**GENOA CHARTER TOWNSHIP  
PLANNING COMMISSION  
PUBLIC HEARING  
JUNE 9, 2014  
6:30 P.M.  
AGENDA**

**OPEN PUBLIC HEARING #1...** Review of site plan application and impact assessment for an 8,000 square feet Medical Building, located at a vacant lot on Grand River, Brighton, Parcel # 4711-14-200-023, south of Grand River between Hubert and Grand Beach. The request is petitioned by Howard Lipkin.

<b>Attention:</b>	Mike Archinal, AICP Township Manager
<b>Subject:</b>	Lipkin Medical Office Building – Site Plan Review #2
<b>Location:</b>	Grand River Avenue – south side of Grand River, west of Hubert Road
<b>Zoning:</b>	NSD Neighborhood Services District

**Re: Lipkin Medical Building  
Site Plan Review #2**

TITLE: **LIGHTING PLAN**

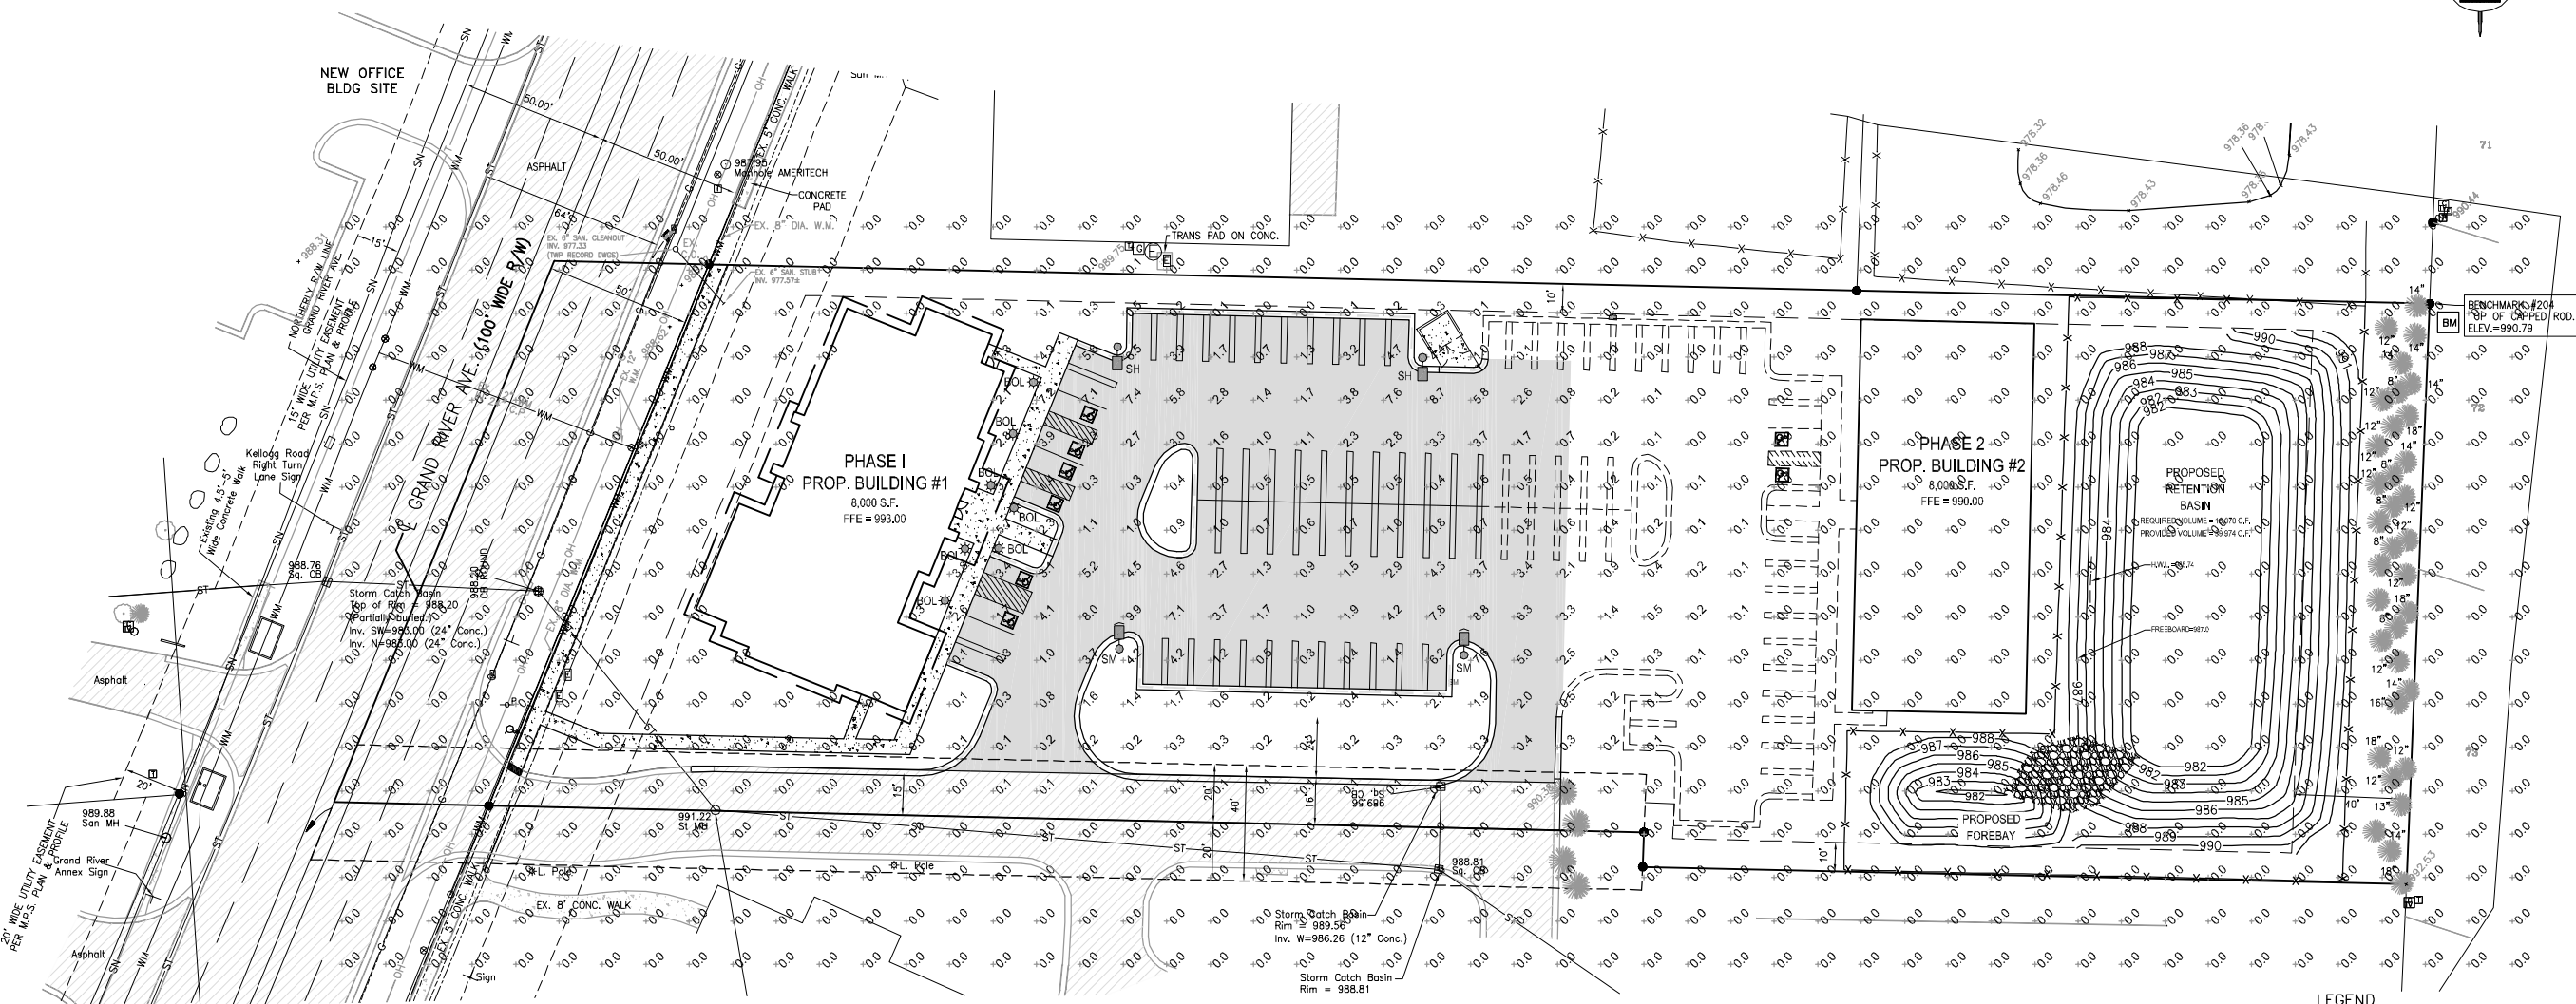
- 9. Exterior Lighting.** Sheet C6 proposes 4 light poles in the parking lot and 7 bollards along the south side of the building. Pole height and light intensity readings comply with Section 12.03. Sheet C11 includes a fixture detail, which notes the use of downward directed, cut off fixtures, as required.
- 10. Signs.** A monument sign is proposed to be incorporated into a brick wall extending from the west façade. The placement of the monument sign is indicated on the architectural plans as extending 22 feet from the edge of the building. This placement results in a setback of approximately 20 feet, but this should be shown on the site plan with the setback noted. Materials noted are consistent with those used for the building and its dimensions comply with the Ordinance.

PROJECT: LIPKIN MEDICAL OFFICE BUILDING  
 PREPARED FOR: DR. LIPKIN  
 3172 INTERLAKEN STREET WEST BLOOMFIELD, MI 48323  
 TITLE: RETENTION & HYDRAULICS PLAN

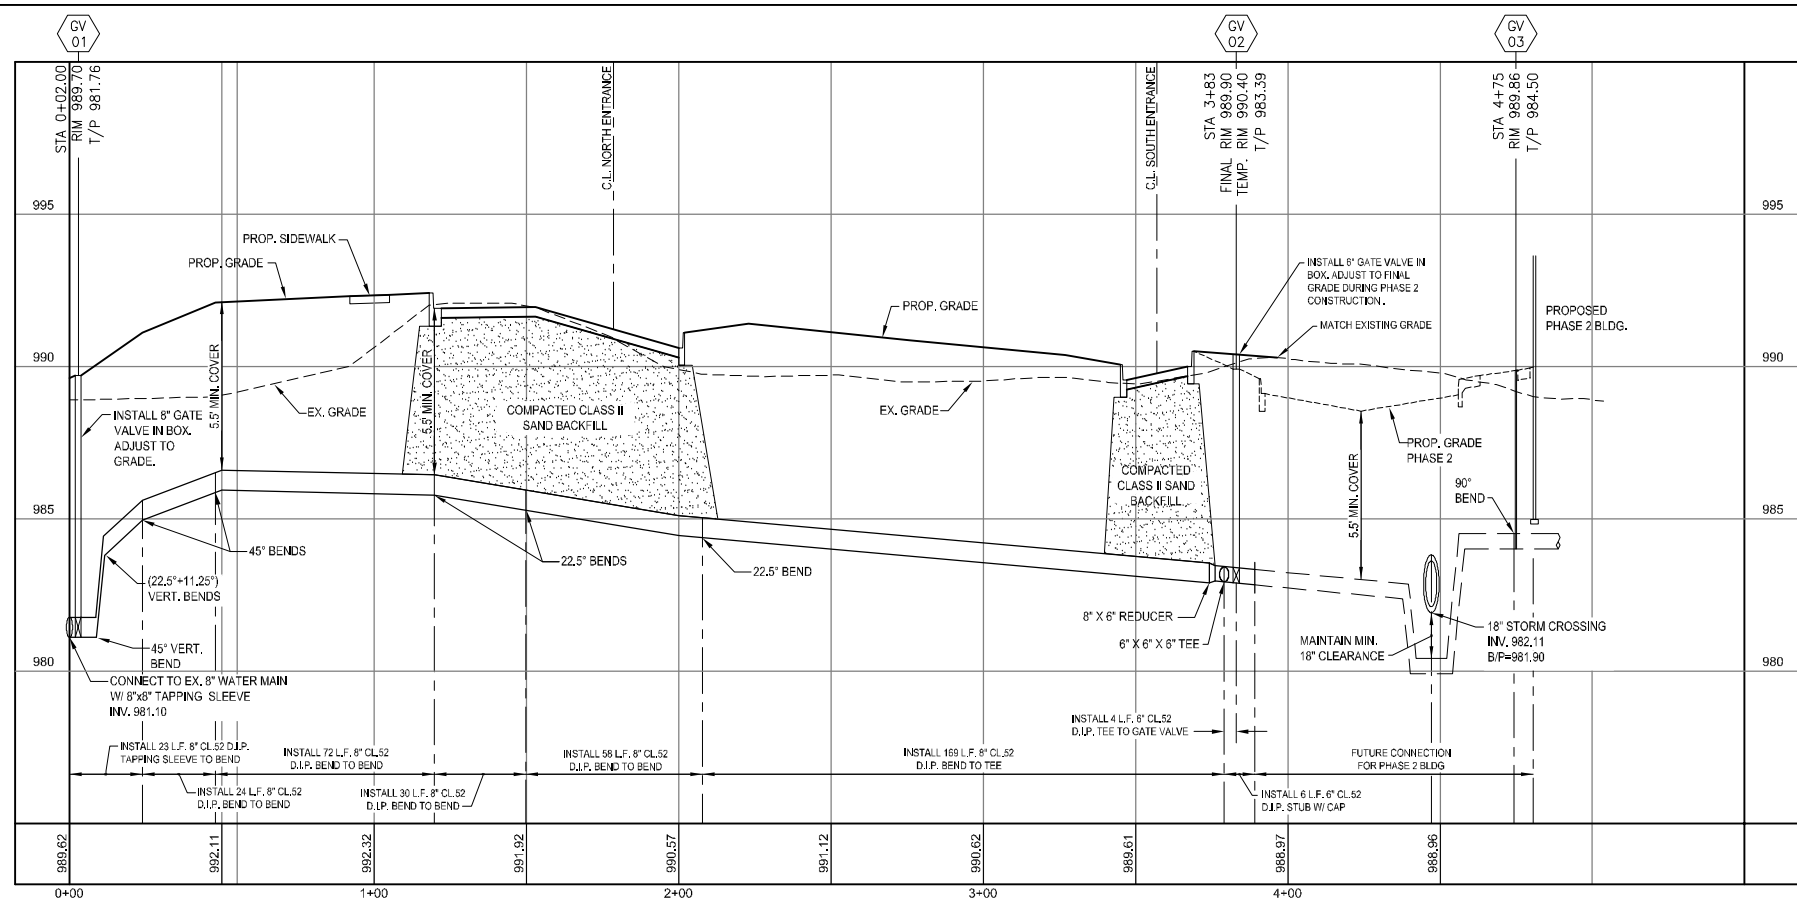
1. Storm sewer labels have been added to the plan view, to match the pipe schedule.
2. As confirmed by Tetra Tech on May 21, 2014, minimum storm sewer pipe slopes shown on the plans are acceptable as is, since the official revised Genoa Engineering Design Standards are not yet ready for issue.
3. Drainage patterns have been revised due corrections in the grading at the north entrance.
4. Roof runoff will be directed to building downspout leads and a 10" PVC perimeter collection system which will drain into catch basin #7.

North (Grand River) Elevation  
Scale: 3/16" = 1'-0" May 21, 2014

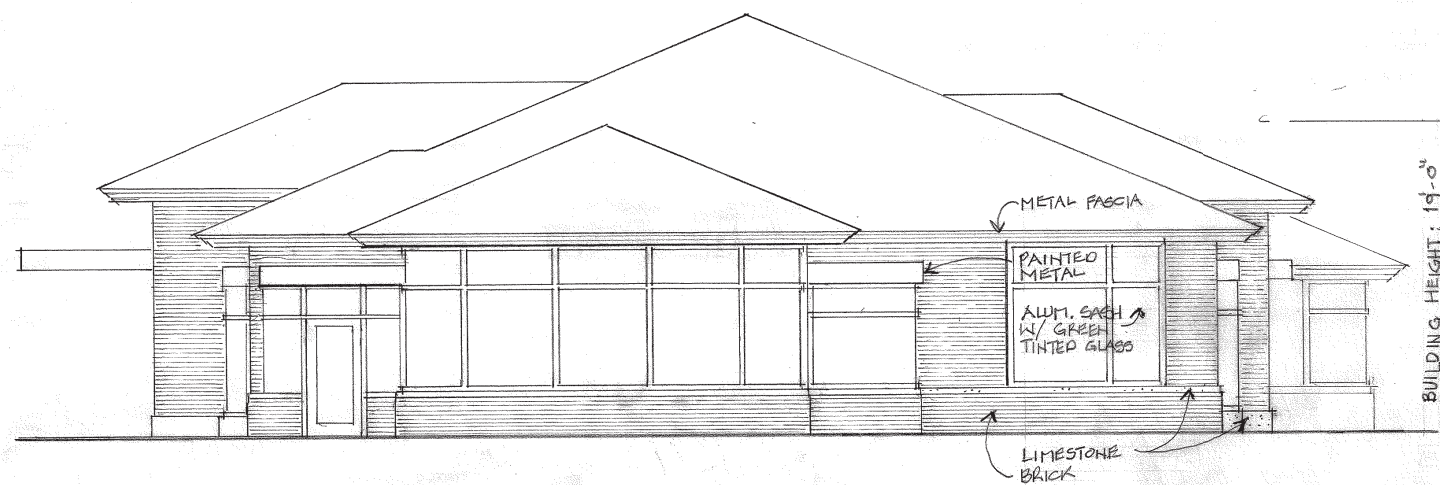
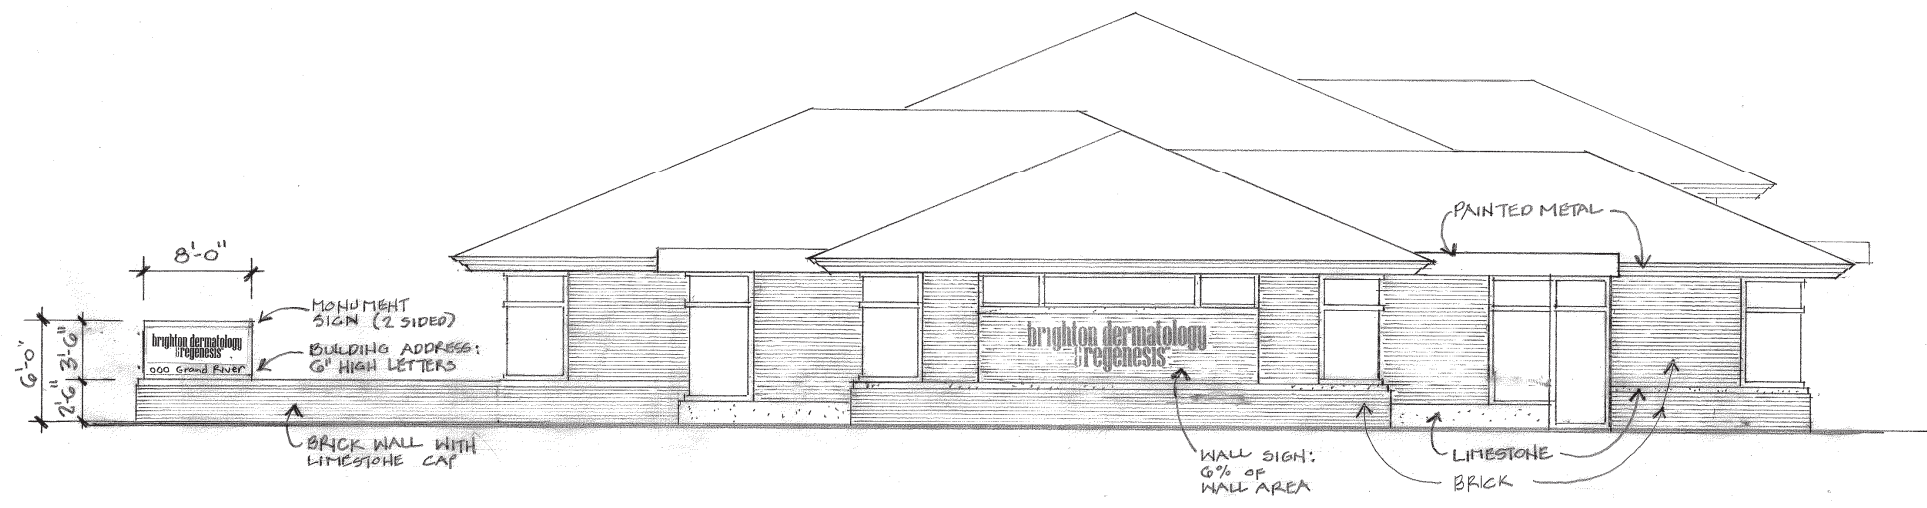
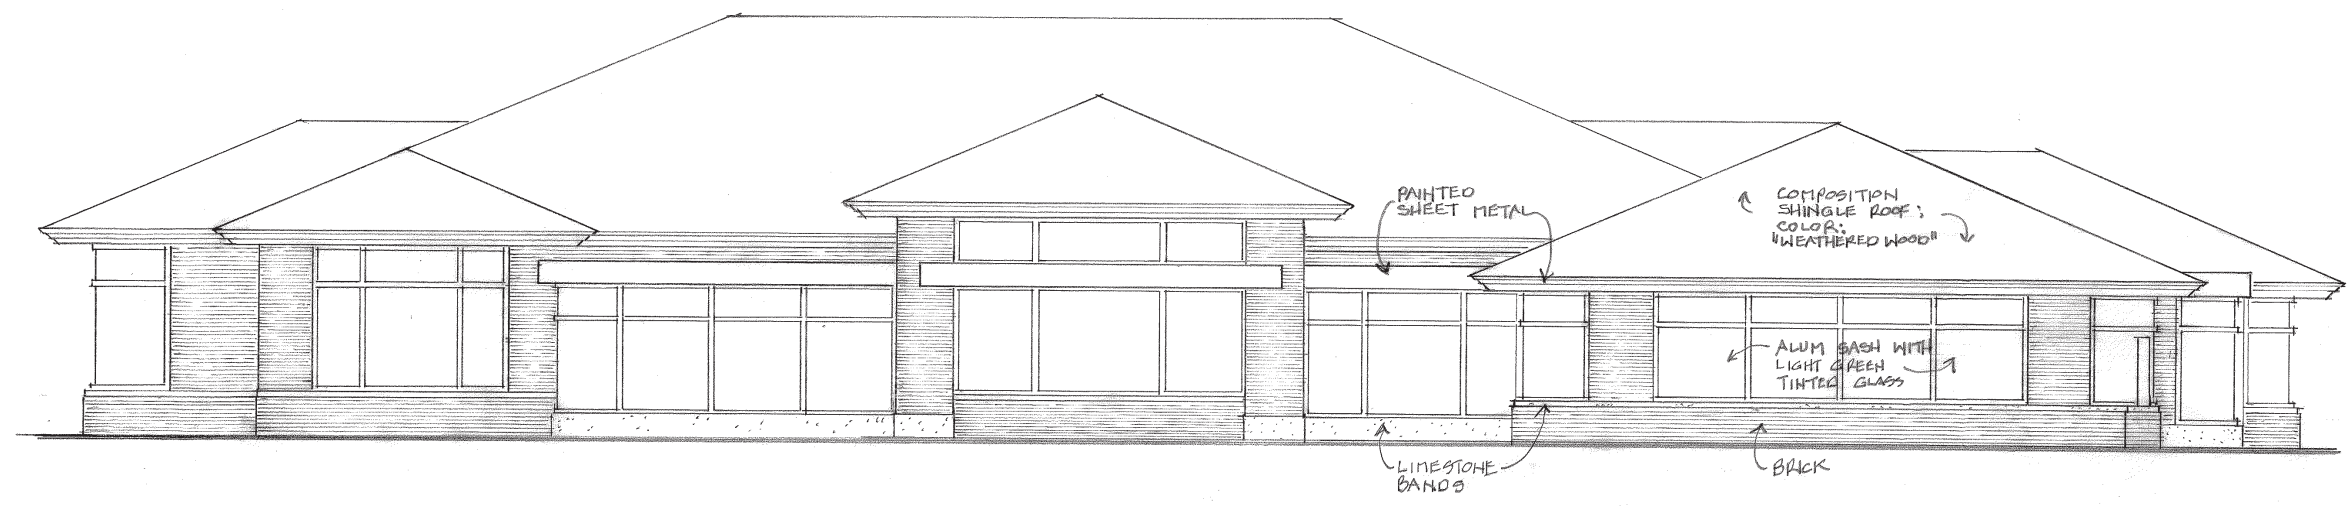
**2. Building Materials and Design.** Proposed elevations, including colors and materials, are subject to review and approval by the Planning Commission. The submittal includes elevation views of each side of the building and a color rendering. In accordance with Table 12.01.03, the submittal includes a table of building materials, however the percentages include door and window glass. As the building is proposed to be predominantly brick and limestone, the painted sheet metal accents appear to be below the 25% maximum allowed.

1. The building height has been reduced to be a maximum of 20 feet.
2. The building materials have been label on the elevations.
3. The material calculations have been added to the building elevations.

9. A sign design has been added to the building elevations.
